Item 4.**Development Application: 14 and 16 Trinity Avenue, Dawes Point - D/2026/298****File Number: D/2026/298****Summary**

Date of submission:	7 April 2026
Applicant:	Aidan Norden
Architect/Designer:	David Selden Design
Owner:	Daniel Tower and Tobias Buchanan
Planning consultant:	GSA Planning
Heritage consultant:	Cracknell and Lonergan Architects
Cost of works:	360,597.16
Zoning:	R1 General Residential. The proposal is for alterations and additions to existing residential dwellings which is permissible with consent in the zone.
Proposal summary:	The subject application seeks consent for alterations and additions to the existing 2 x two-storey terrace dwellings, comprising rear second storey wing additions with internal spiral staircases for access. The terraces are State Heritage listed (SHR 00911) and are located within the State Heritage listed Millers Point heritage conservation area (SHR 00884) and the Millers Point and Dawes Point village precinct (SHR 01682). The application is Integrated Development requiring the approval of Heritage NSW under the Heritage Act 1977. General Terms of Approval were issued by Heritage NSW on 8 July 2026. This application is referred to the L

Figure 18: Proposed section through the development, depicting the existing height plane in green dashed lines, and existing ground level in red dashed lines

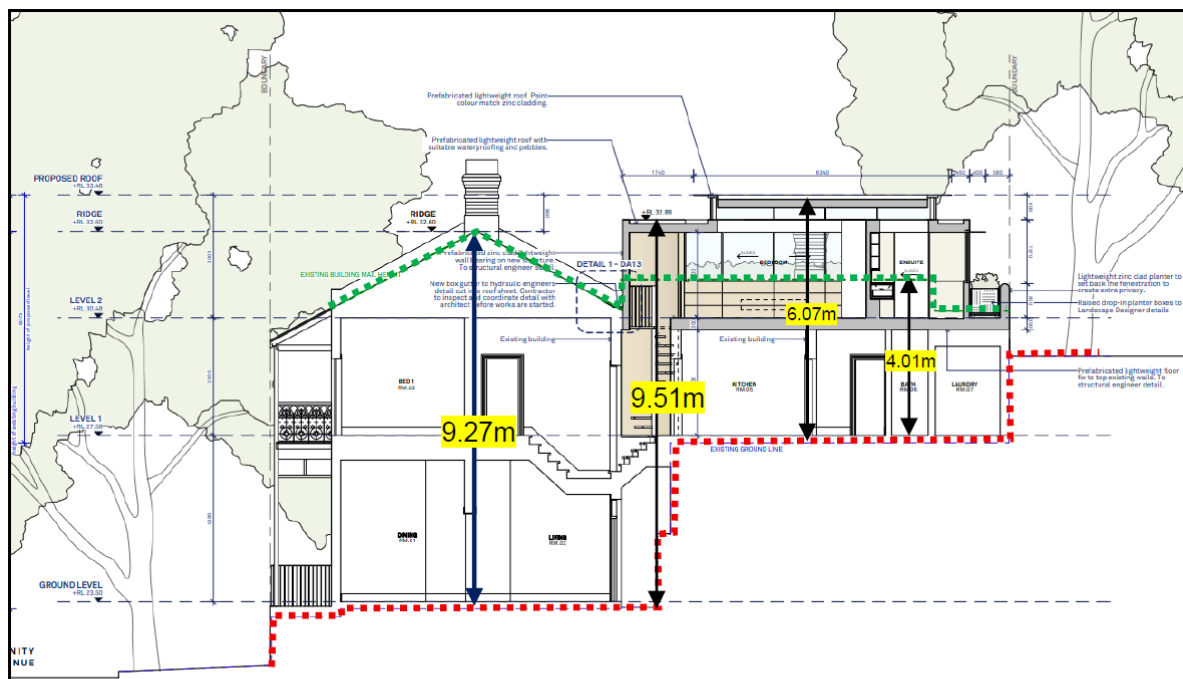
37. The site is subject to the site specific controls of Clause 6.47 'Millers Point heritage conservation area' of the Sydney LEP 2012. The site is identified in 'Area 10' on the Height of Buildings Map. In accordance with Clause 6.47, the maximum height of a building that is a heritage item is the height of the building on the land as at the commencement of this clause (at 18 October 2019).
38. The existing rear additions are 4.01m in height, and the area where the spiral staircases are to be installed has an existing height of 8.04m. The proposed rear additions are 6.075m in height. The stairs are 9.51m in height.

41. Development consent must not be granted unless the consent authority is satisfied that the applicant has demonstrated that compliance with the development standard is unreasonable or unnecessary in the circumstances of the case, and that there are sufficient environmental planning grounds to justify contravening the standard.
42. The applicant has demonstrated that compliance with the standard is unreasonable or unnecessary in the circumstances of the case and that there are sufficient environmental planning grounds to justify contravening the standard for the following reasons:

- (a) The applicant has demonstrated that the proposed development achieves the objectives of Clause 6.47. With consideration to development in the Millers Point heritage conservation area that is not a heritage item, the permitted height is 9m and FSR is 2:1, The proposal is generally consistent with the permitted height and FSR controls and therefore the desired future character of the locality.

- (b) The proposed additions are to have a lightweight, contemporary appearance to be clearly discernible as new development. The additions have been sited to reduce any impacts on heritage significant fabric and are not readily visible in the heritage streetscape, conserving the principal view and built form of the terraces in the Millers Point heritage conservation area, and as required by the endorsed conservation management plan for the site.

- (c) The proposal does not result in any significant adverse impact upon the site and surrounds as the proposed design is otherwise in accordance with the relevant amenity controls. The rear additions have been designed so that they do not remove solar access to surrounding development at the winter solstice, and setback from the north and south side boundaries to reduce sightlines to neighbouring courtyards and windows.
